Brewer Arena Improvements

Parks and Recreation Board
December 11, 2025

Grandstand & Pavilion

Grandstand w/Enlarged Pavilion (Option)

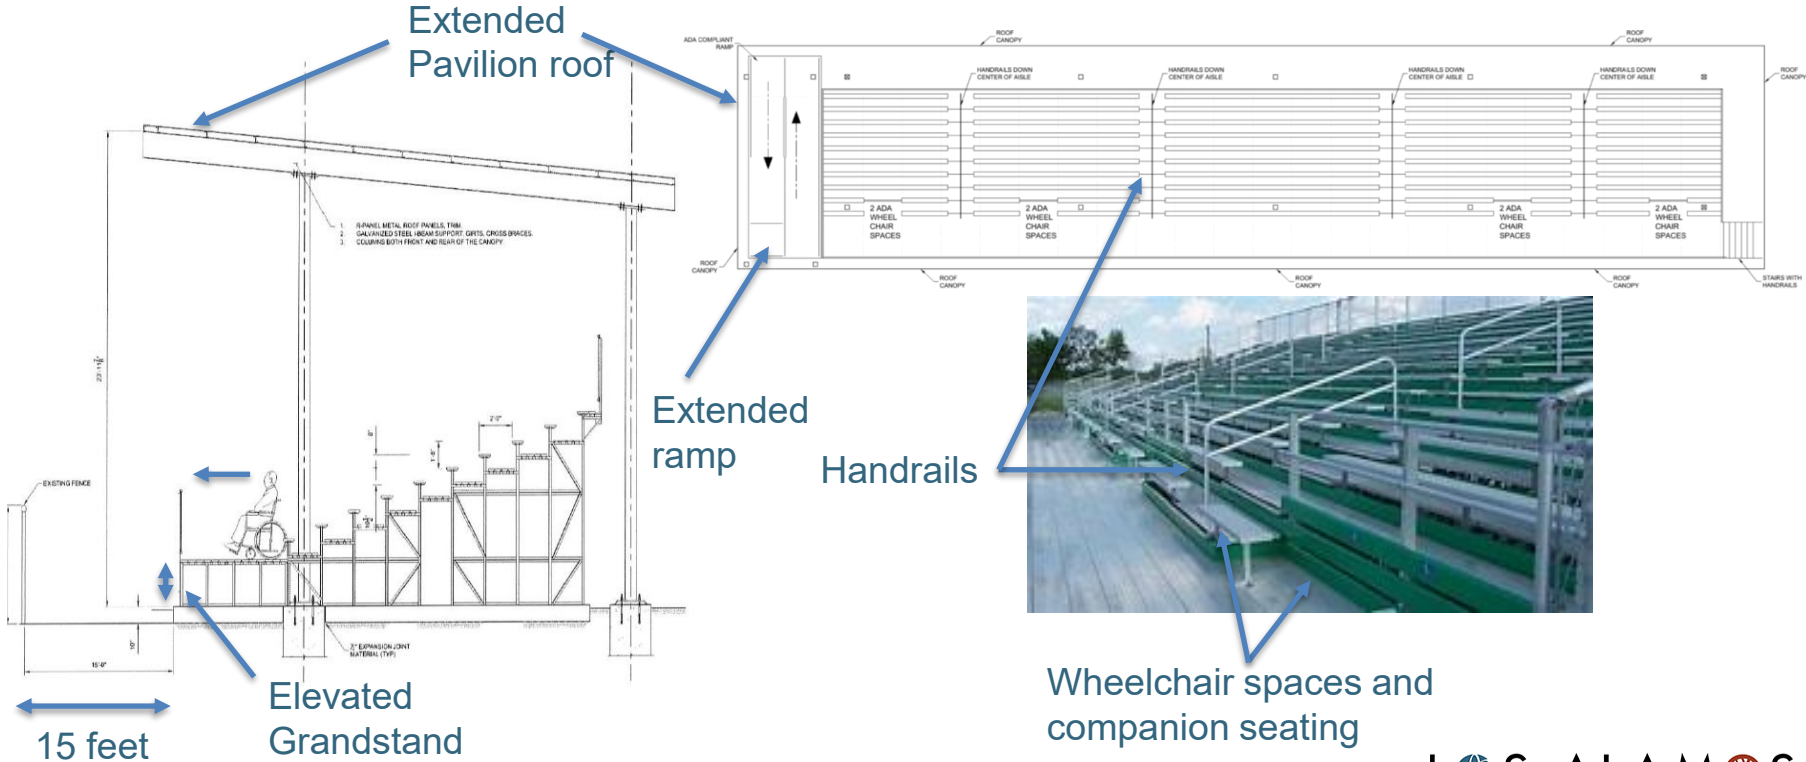
- Adjust elevation so that first row has unobstructed view over arena fence
- Center the seating on the “50 Yard Line”
- Grandstand to be 15’ away from arena fencing
 - West side arena access gates need to be unobstructed
- Make seating steps shallower/less steep and with handrails
- Extend the pavilion to provide cover for the entire seating, access ramp, and walkway

Additional Feedback from Equestrian Working Group

Grandstand elevation increase	\$ 90,000
Pavilion extension	\$192,000
ADA Ramp extension	<u>\$ 38,000</u>
TOTAL:	\$320,000
- Support raising the grandstand and adjusting the ADA ramp
- Support not extending the pavilion roof to reduce impact on project budget
- No consensus regarding appropriate grandstand capacity (next two slides)

- Raise Grandstand elevation (requires extension of ADA ramp)
- Center Grandstand on “50 Yard Line”
- Place Grandstand 15’ from the arena fencing
 - Ensure access gates are unobstructed
- Seating incline and handrails meets standards
- Correct obstruction of arena access gates if needed
- Enlarge Pavilion
- Estimated Budget Impact: \$320,000

Grandstand Seating Capacity

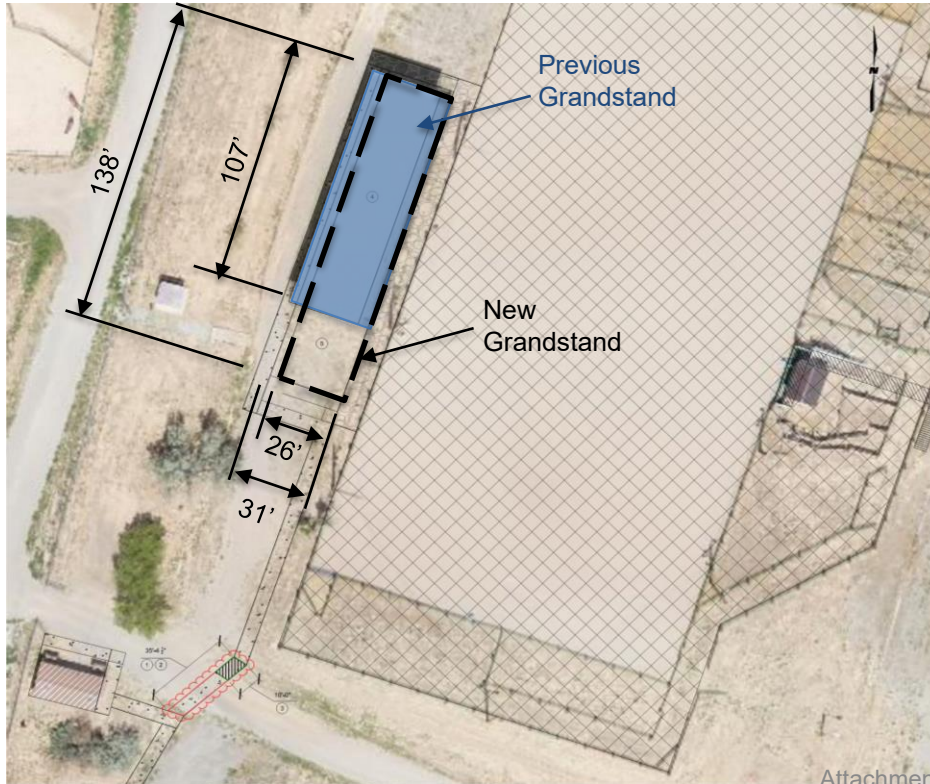
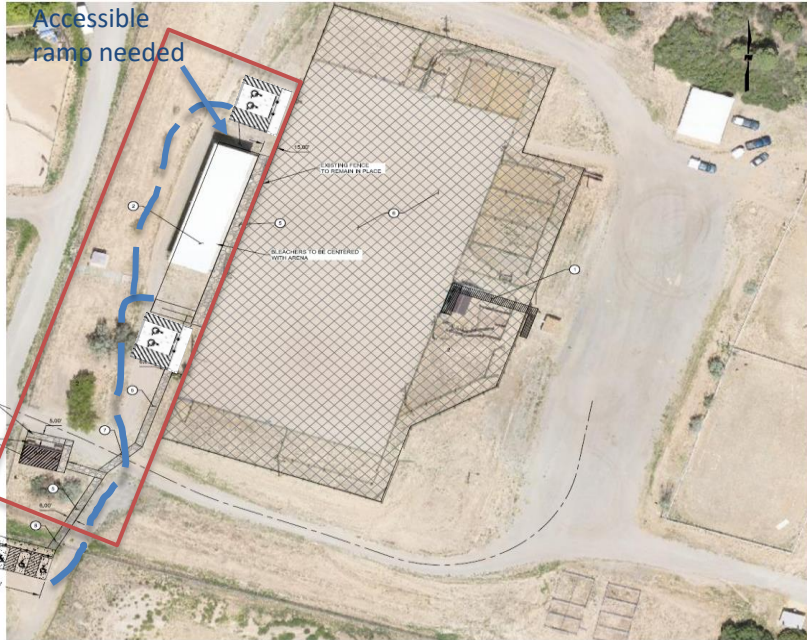
Presented to PRB on Oct. 23, 2025
Seating capacity will not be increased

15 rows – 1,500 linear feet seating
Approx. 1000 seats (18-inch/person)
Footprint - 107' × 31' (3,320 sq. ft.)

10 rows – 1,178 linear feet seating
Approx. 768 seats (18-inch/person) plus
8 – wheelchair spaces
Footprint – 138' × 26' (3,600 sq. ft.)

Restrooms

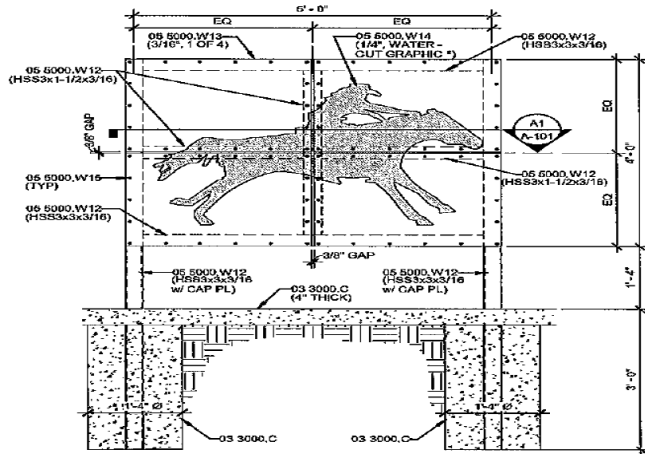
- Sink placement does not allow turnaround wheelchair access
- Restroom capacity will not satisfy the full demand

Feedback from LASOA & ELWG

- Restroom upgrades meet ADA requirements
- Restroom capacity can be increased through the placement of temporary facilities when needed

- Requested code analysis
- Architect of record states that the restroom design is conducted in accordance with ADA standards *ANSI A117.1* as adopted by the State of New Mexico and as listed in the *2021 International Building Code*. Specific ADA of A117.1.
